URBAN DESIGN BRIEF

601 LAURIER AVENUE

21 MARCH 2025

Response to UDRP Comments

Previous Massing

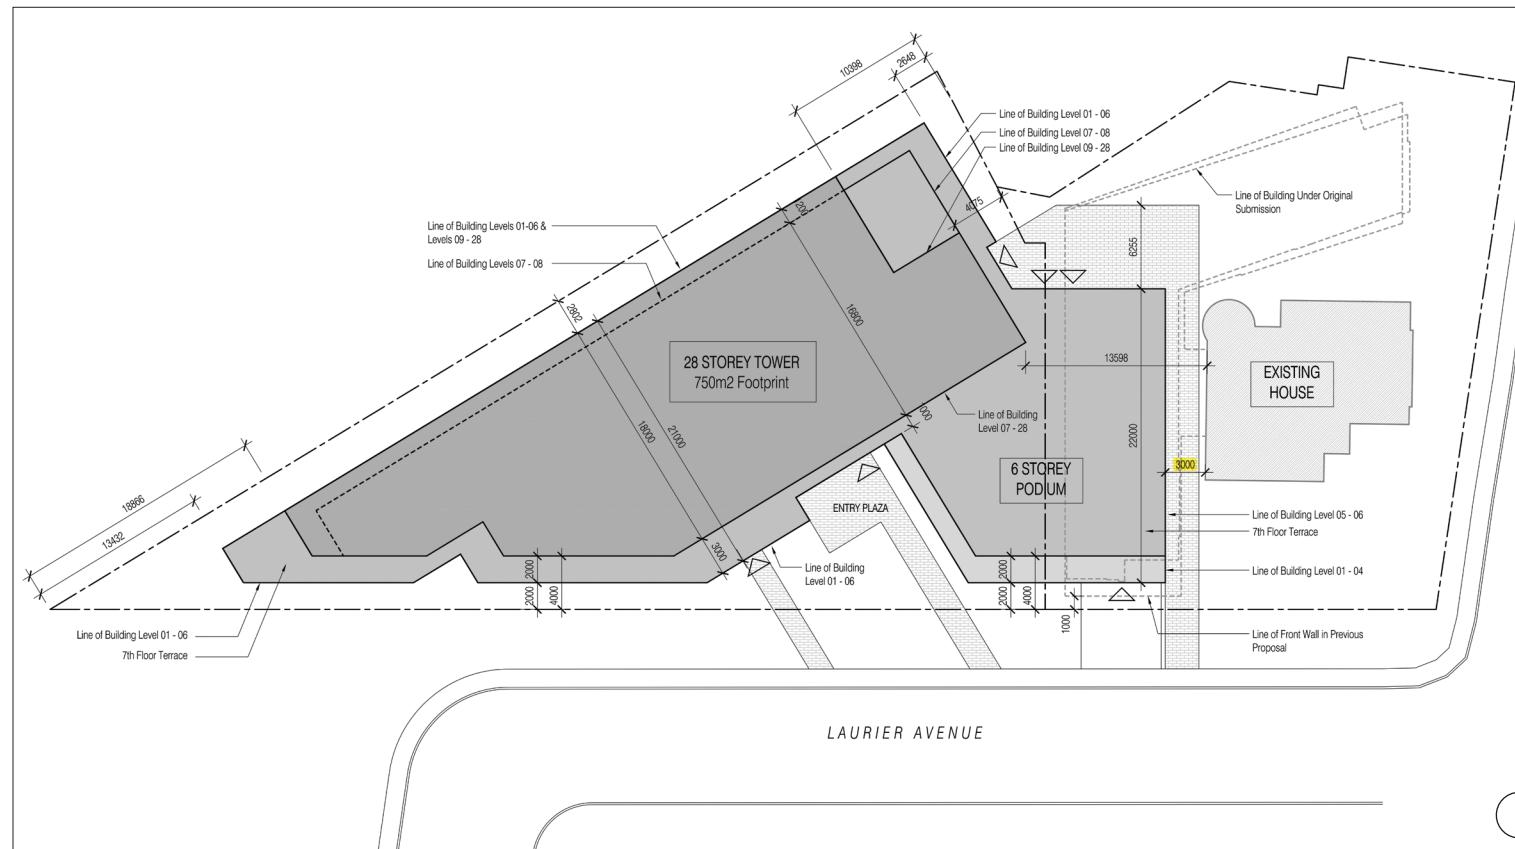
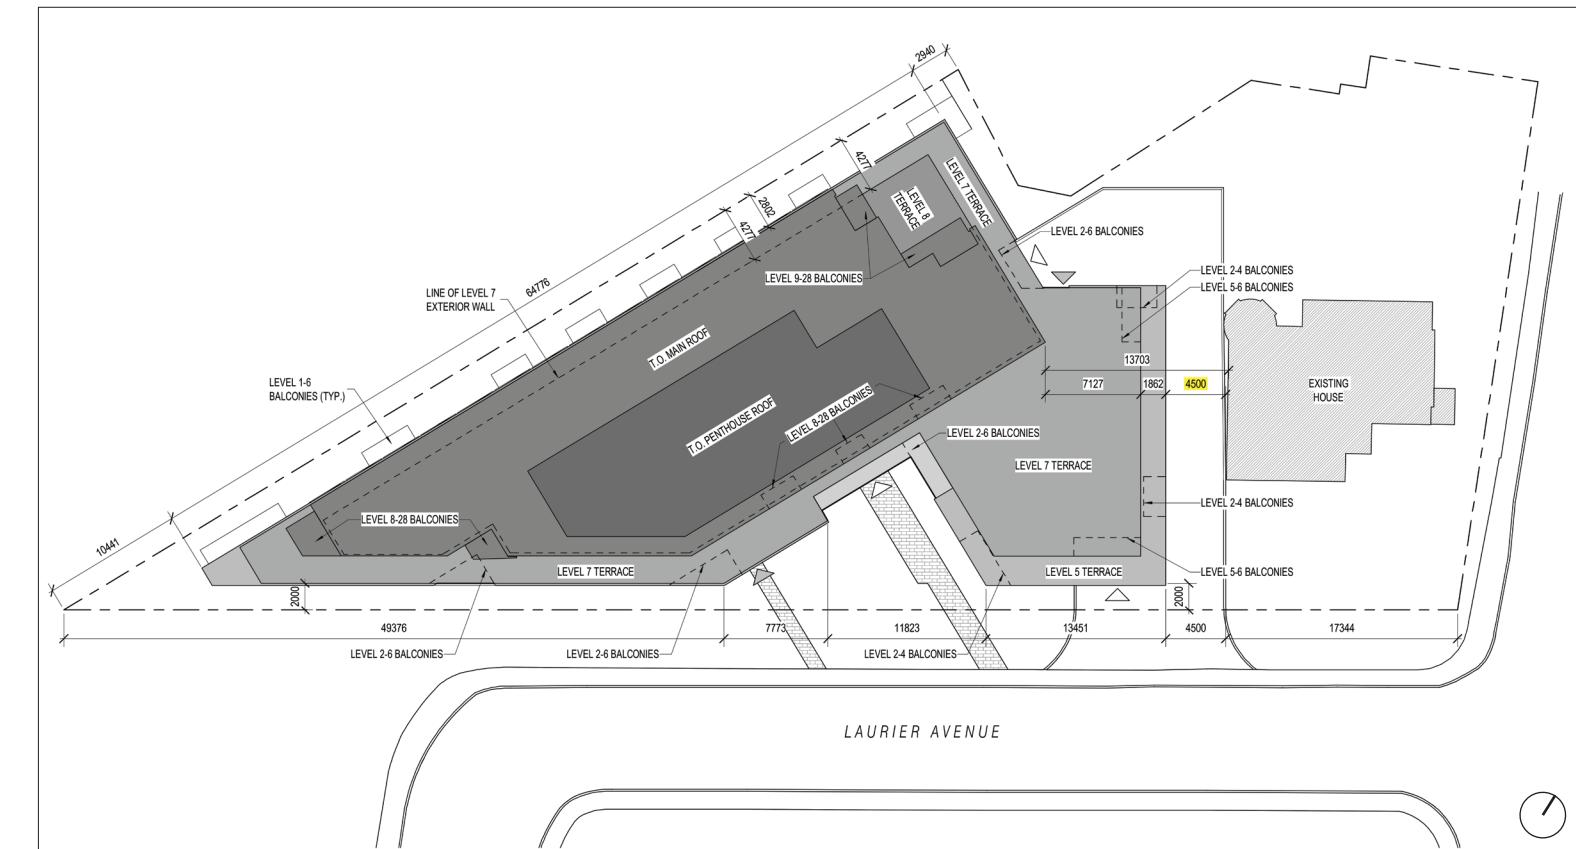
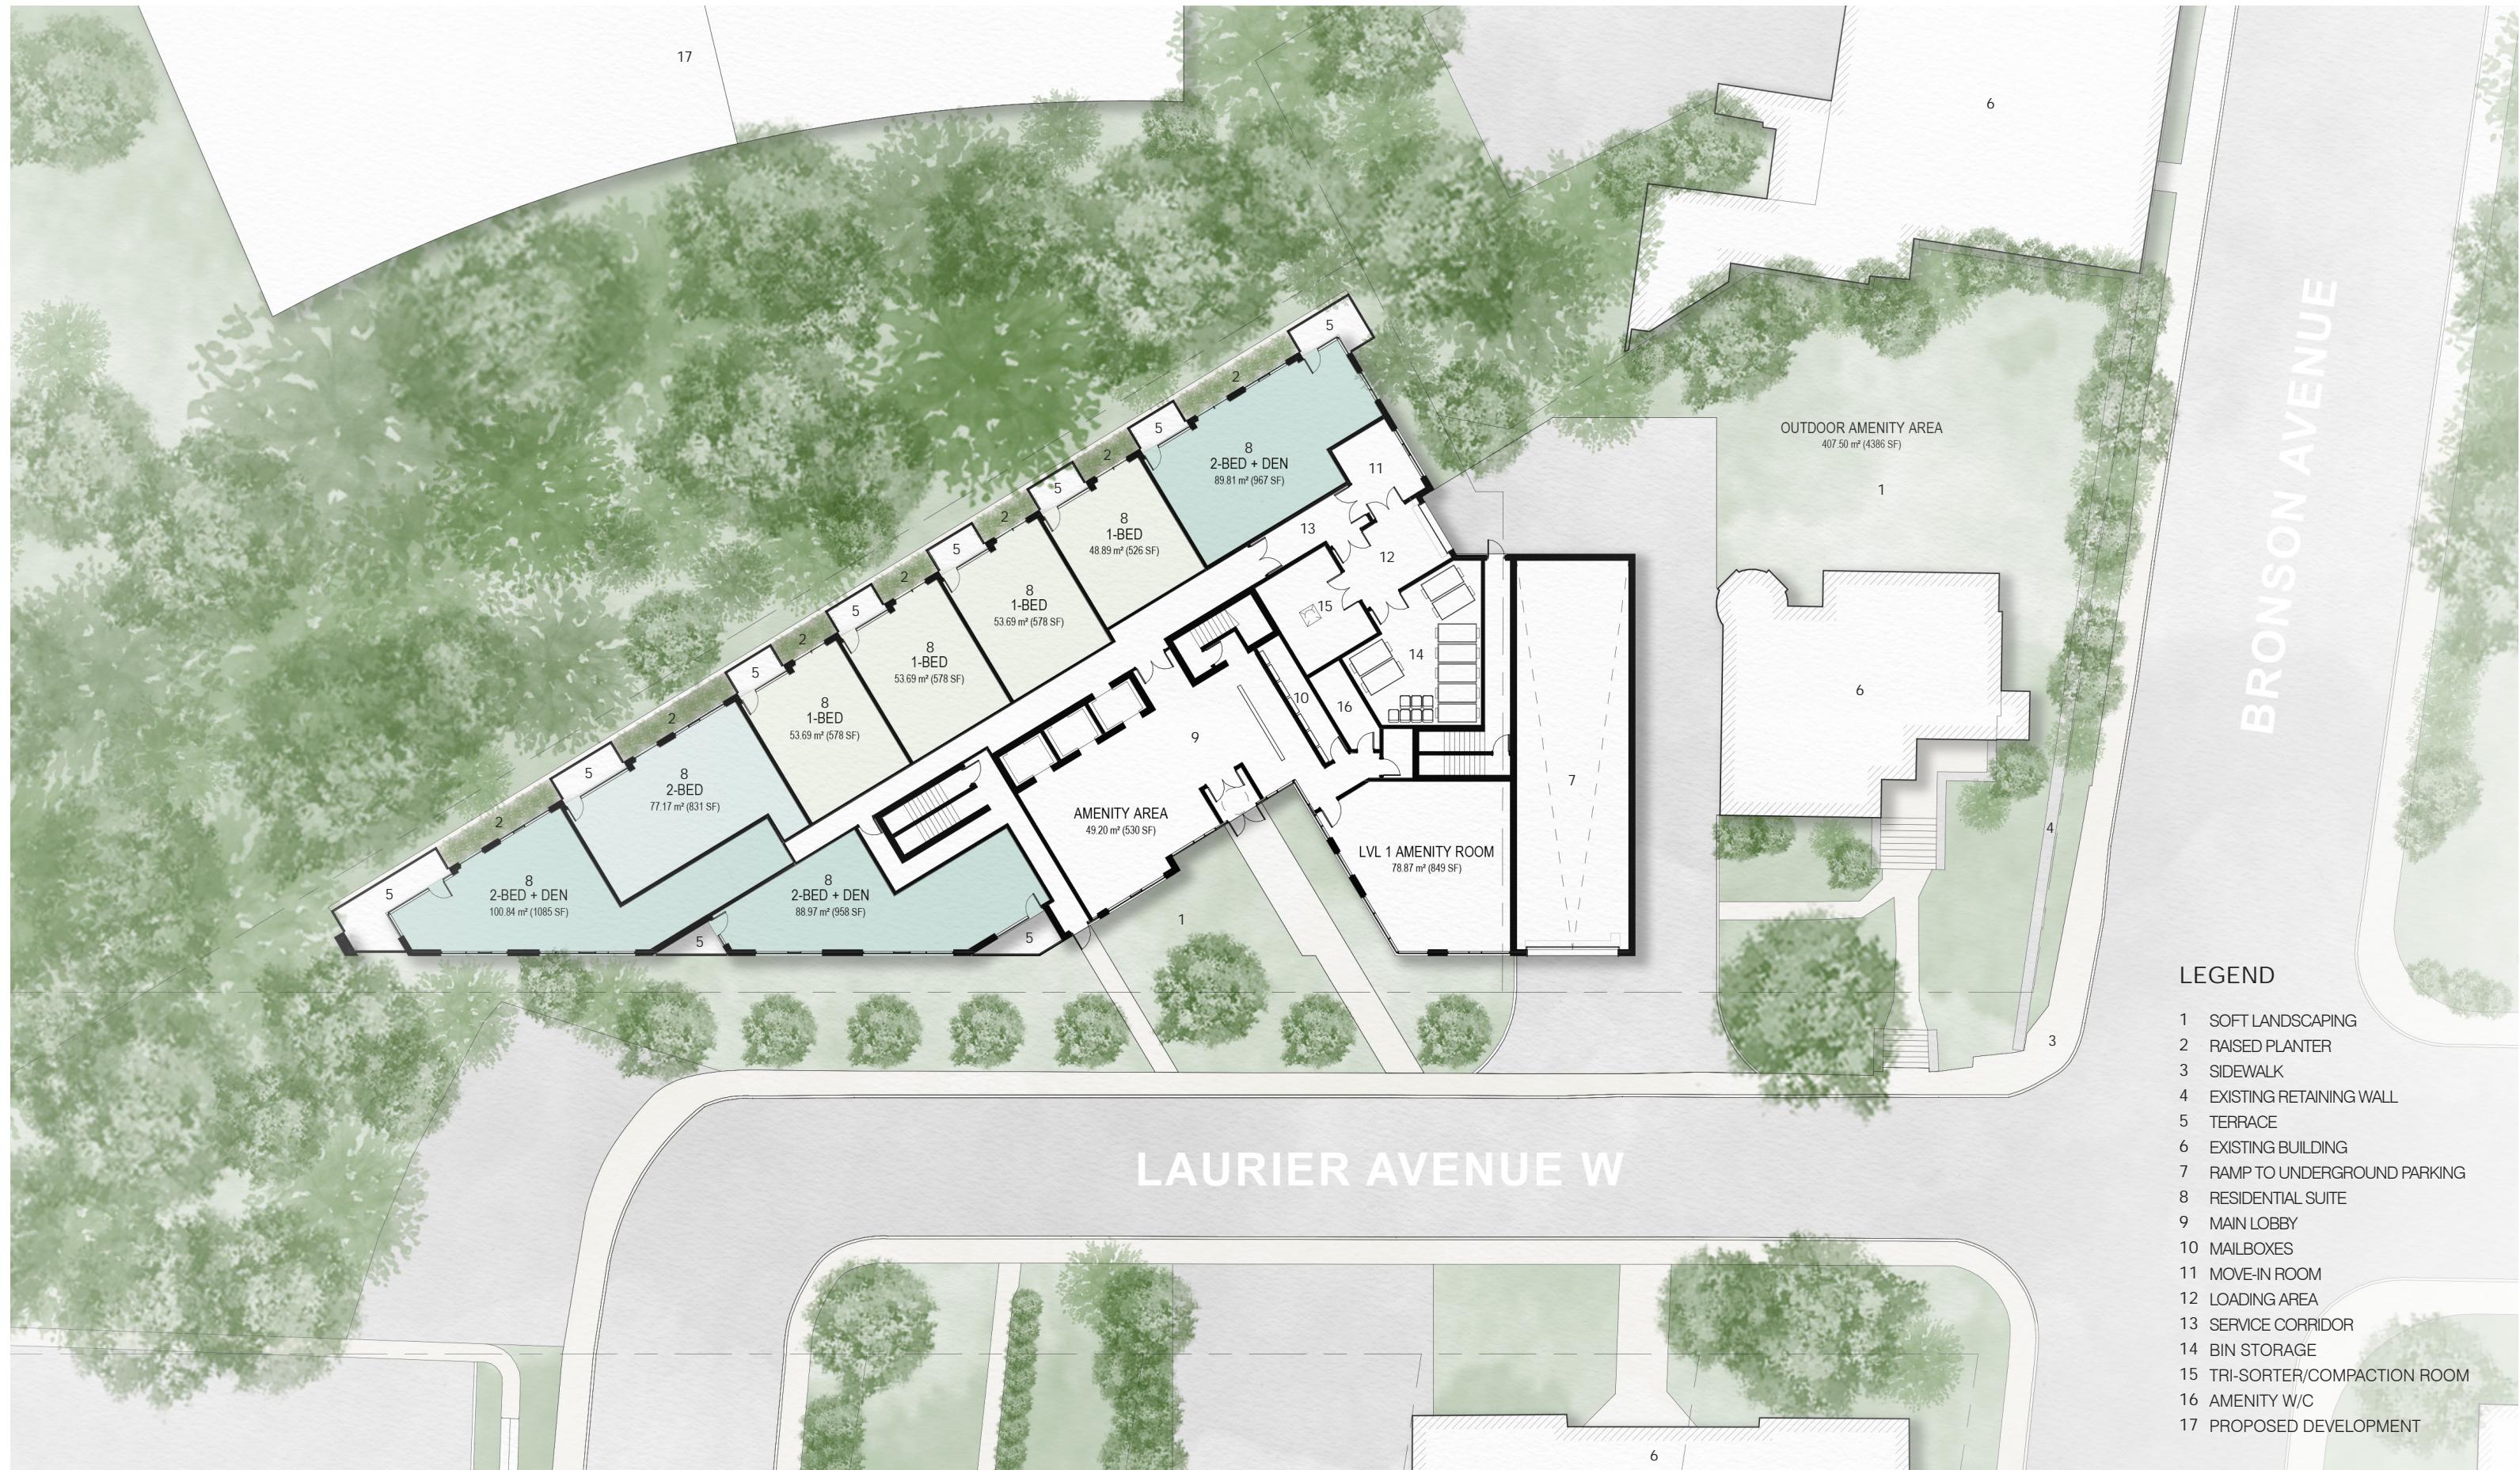
The podium may be high for the neighbourhood context and especially the relationship to the heritage house on the property. We recommend providing additional design/massing details so we may better understand the approach being taken.

We have increased the separation from the heritage house to 4.5m from 3m and introduced a stepback and material change above level 4 to better integrate the podium with the neighborhood context. These adjustments help to mitigate the podium height and ensure a more harmonious relationship with the heritage house.

The initial massing concept positioned the proposed development 3 meters from the existing Heritage House for the first six storeys of the podium. This approach was primarily driven by the objective to maximize leasable space, providing ample room for residential units while maintaining vehicular access to essential building services at the rear. This configuration, however, raised concerns about the proximity to the Heritage House and its impact on both the historical context and practical access, and required further consideration to improve spatial dynamics and circulation.

In response to these concerns, the current design iteration has been refined to enhance both spatial and aesthetic relationships. The podium has been shifted an additional 1.5 meters away from the Heritage House, resulting in a total separation of 4.5 meters. Furthermore, levels five and six of the podium are now recessed an additional 1.8 meters, creating a more gradual transition to the tower levels above. The first four levels of the podium, which align with the height of the Heritage House, will feature red-tone brick complimenting the red brick of the existing structure. This material choice reinforces the architectural dialogue between the new and existing building.
